Freeport-McMoRan Chino Mines Company
P.O. Box 10
Bayard, NM 88023

Re: Response to Request for Additional Information, Revision 24-2, 2024 CCP Update, Chino Mine, Permit No. GR009RE

Freeport-McMoRan Chino Mines Company (Chino) submitted an update to the Chino Closure- Closeout Plan on October 30, 2024. On October 28, 2025, Chino received comments from the New Mexico Mining and Mineral Division and other state agencies. This letter provides responses to these combined comments. Below are the agency comments in italics followed by Chino's responses.

NMA REVEGETATION PLAN

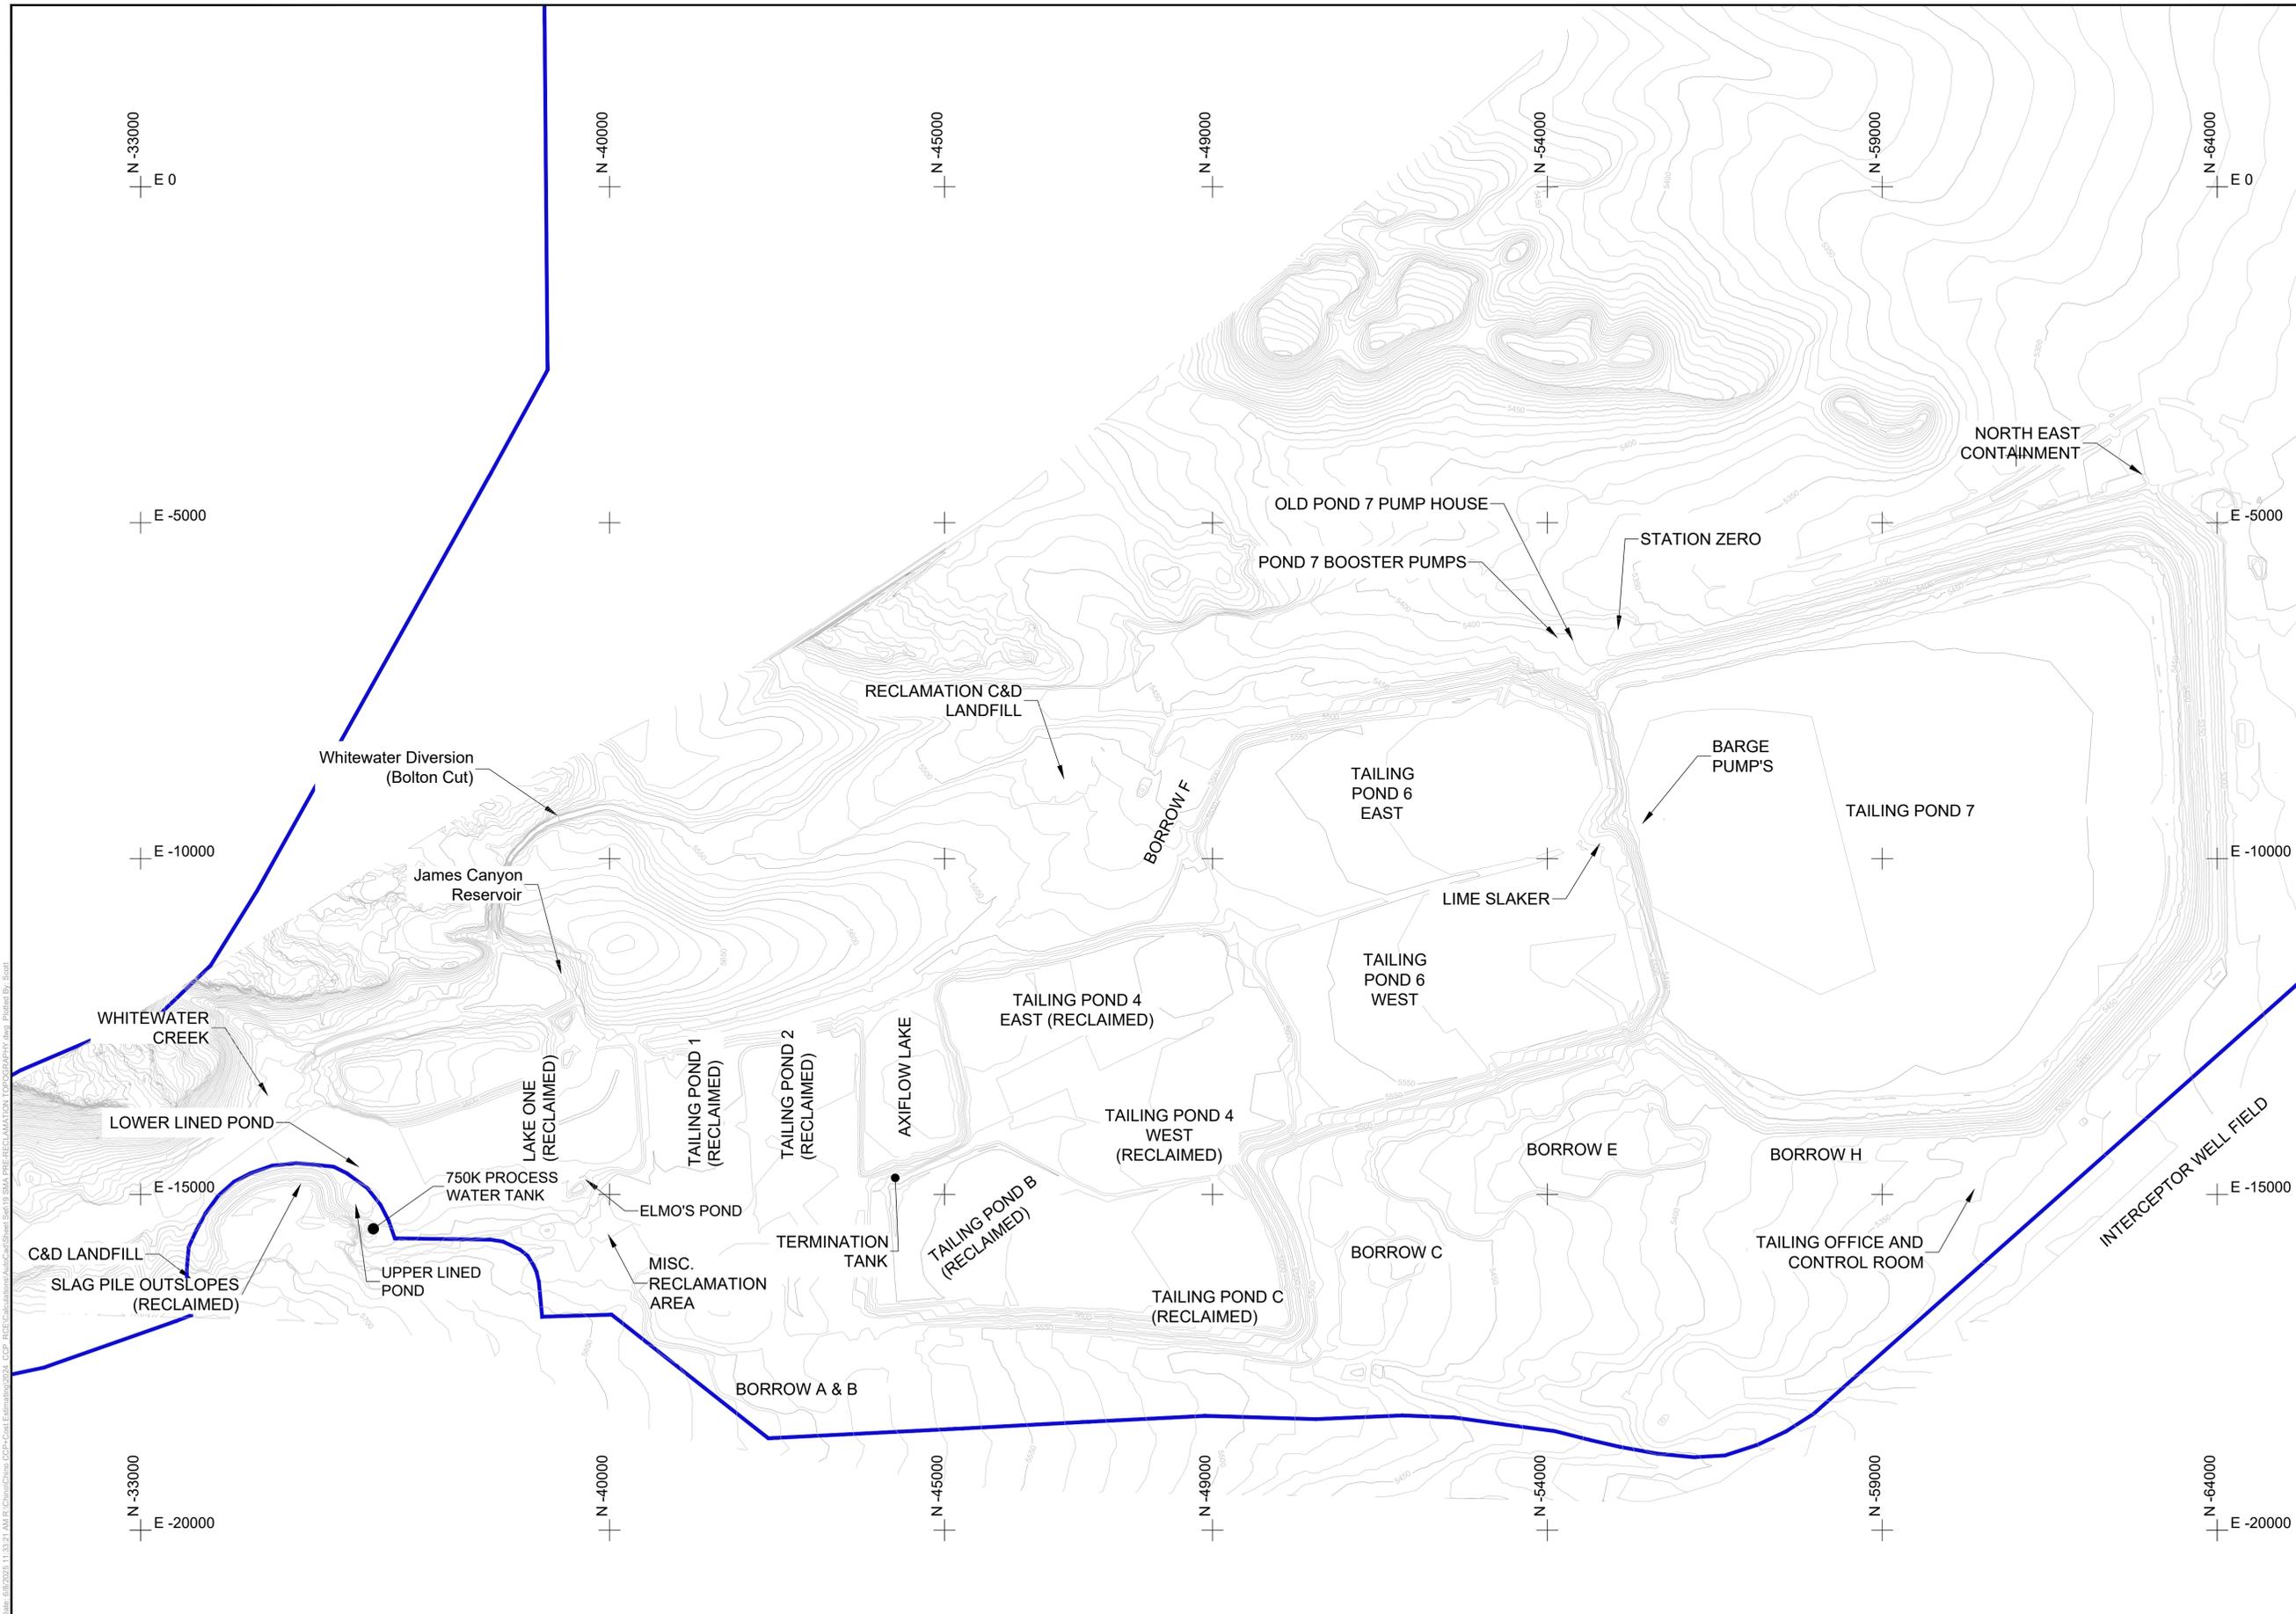
- The area on top of the West Stockpile dedicated to the salt/sludge storage is depicted inconsistently throughout the PAP, with varying extents described on Sheet 18, Figure 11, and Appendix G Figure 2. Please provide a new map detailing the extent of the West Stockpile that will be given the PMLU of Water Management compared to that which will be reclaimed as Wildlife Habitat or any other use.

Telesto calculated that the volume of salt generated could be stored within the area of the West Stockpile shown on Appendix G Figure 2; however, this may not be the best location considering surrounding reclamation, potential run-on issues and the need to avoid impacts to slopes and the Waiver area toward the Santa Rita Open Pit. Since the West Stockpile location generated the above final design-level questions, Chino proposes relocating the salt disposal facility for this conceptual design to the top surface of the North In-Pit Leach Stockpile and North Waste Rock Stockpile. A conceptual design of this facility is provided in revised Appendix C Sheet 11 and Figure 2 of Appendix G.

Figure 2: CDF plot of all data, 10% of data, and 25% of data

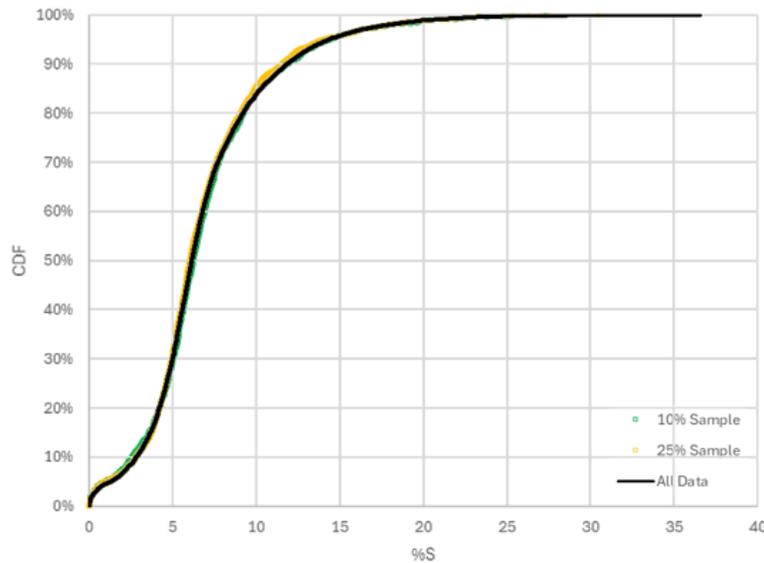
- MMD does not necessarily oppose the reduction in paste pH sampling for in-pit RCM. However, the provided Figure 1 does not sufficiently demonstrate that a reduction in sampling will allow Chino to continue to adequately characterize in-pit RCM with pH <5.0.

- Please provide additional analysis similar to Figure 1 comparing limited sampling populations that is based on the original paste pH sampling data connected to the percentage sulfur populations shown in Figure 1 (or a separate sampling data set) and provide the original sampling data.

Chino prepared the attached calculation set to further demonstrate the statistical basis for the proposed reduction in sampling frequency. Data used in the analysis is included in the excel sheet titled MHP Statistical Analysis Data. Given the volume of data, Chino will distribute the file electronically via email.

When a sub-set of a larger sample population results in the same population representation (i.e., cumulative distribution function and parametric variables like median), then the sub-set is representative of the larger sample population. The intent of Figure 1 is to show that the sub-set of the sample population adequately represents the entire population. Ergo, a reduction in sampling frequency adequately identifies the percent sulfur in the overall sample set.

Figure 4: Sulfur % vs paste pH plot, from Hanover Mountain blast hole samples and Golder 2006 MHP

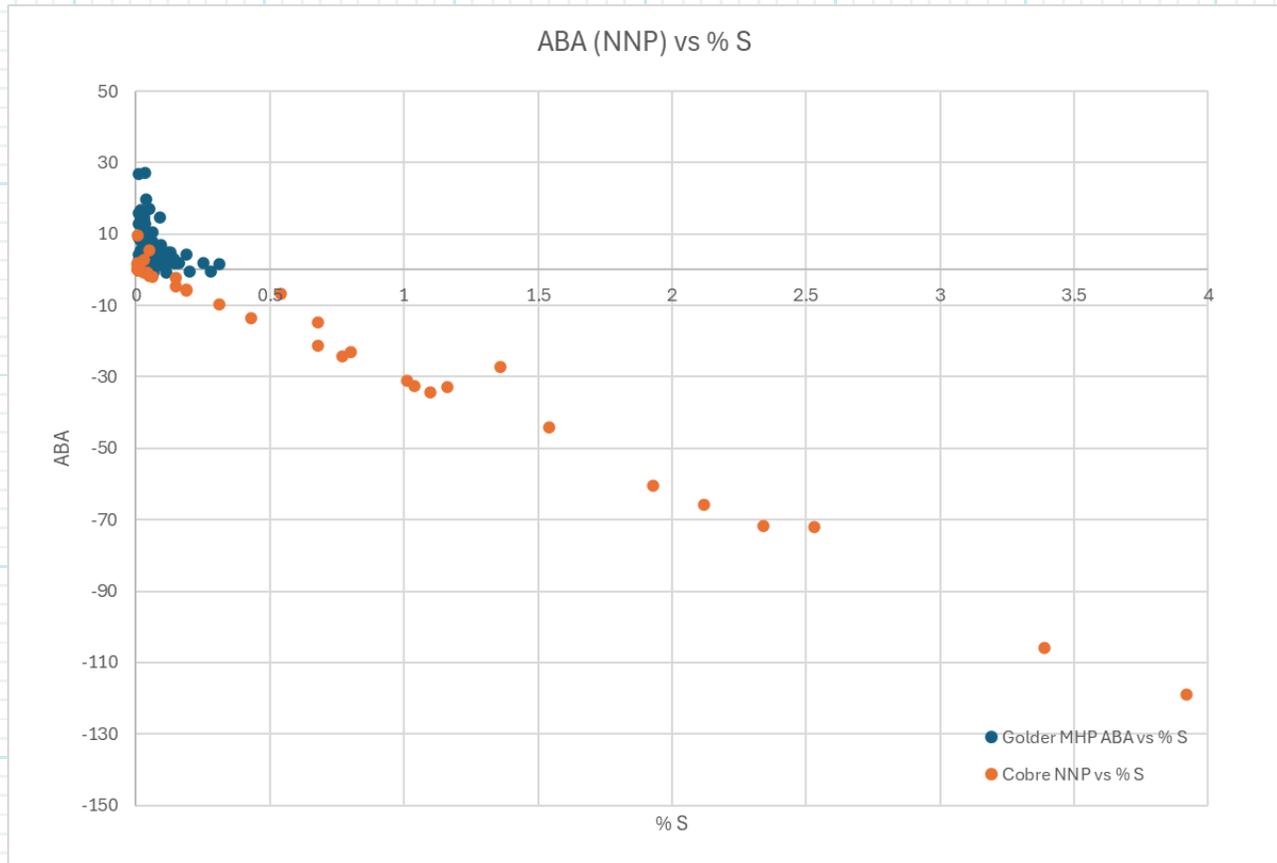
- Please provide a demonstration of the "strong correlation showing that samples with percent sulfur below 0.15% consistently have pH above 5". Such demonstration should include the original lab data the analysis is based upon.

8. Figure 4 illustrates the relationship between percent sulfur and net neutralizing potential (NNP; net acid–base accounting as presented in the original RCM characterization in Golder's 2006 Material Handling Plan) for all available data from the Chino and Continental mines. All samples with sulfur contents below 0.15 percent always exhibit positive NNP values, indicating net neutralization capacity.
